Amendment No. 2

Generation Interconnection Agreement

LCRA Transmission Services Corporation

FPL Energy Upton Wind III, LLC

Exhibit "C-2"
POINT OF INTERCONNECTION DIAGRAM

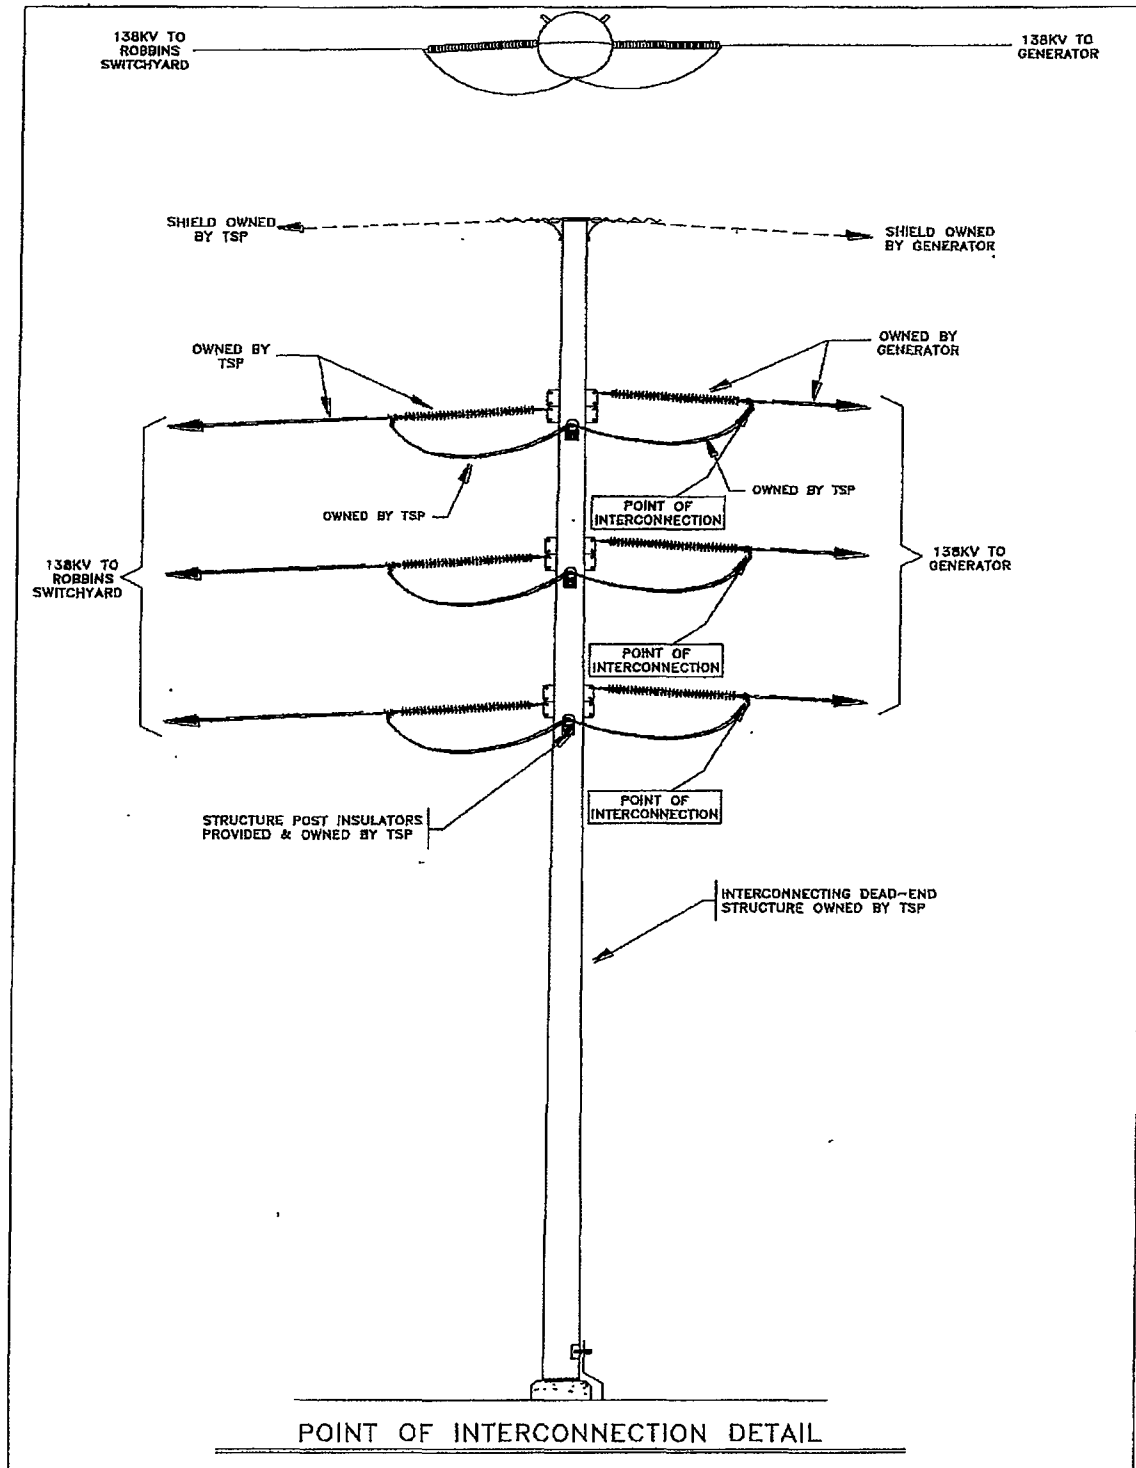
WHEREAS, this amendment to the Interconnection Agreement is necessary because the TSP will install 138-kV circuit breakers to increase transmission service reliability at the Robbins Switchyard and the description of the LCRA TSC Transmission Interconnection Facilities (TIF) requires updating; and

WHEREAS, the ERCOT Polled Settlement metering will be relocated from the plant to the TSP's new switchyard at Robbin Switchyard Substation.

1. Exhibit "C" Interconnection Details (including the diagrams Exhibit "C-1" and "C-2" attached thereto), attached to the agreement, is deleted in its entirety and Exhibit "C" Interconnection Details (including the diagrams attached thereto), attached to this Second Amendment, is hereby added to the Agreement in lieu thereof.

A). TSP's ERCOT polled settlement ("EPS") metering will be located at the TSP Switchyard as part of the TIF. Three 138-kV extended range, metering current transformers will be used to accurately read the generation energy and power delivered to the grid and the auxiliary energy and power consumed through the Point of Interconnection. Three 138-kV metering accuracy voltage transformers will also be installed by the TSP for the ERCOT settlement metering. The ERCOT settlement metering panel furnished by the TSP will be located in the TSP Switchyard.

- (c) Three (3) 145-kV, 3000A circuit breakers in a ring-bus configuration
- (d) Six (6) 138-kV, 3000A VAB switches
- (e) Nine (9) 138-kV coupling capacitor voltage transformers "CCVTs"
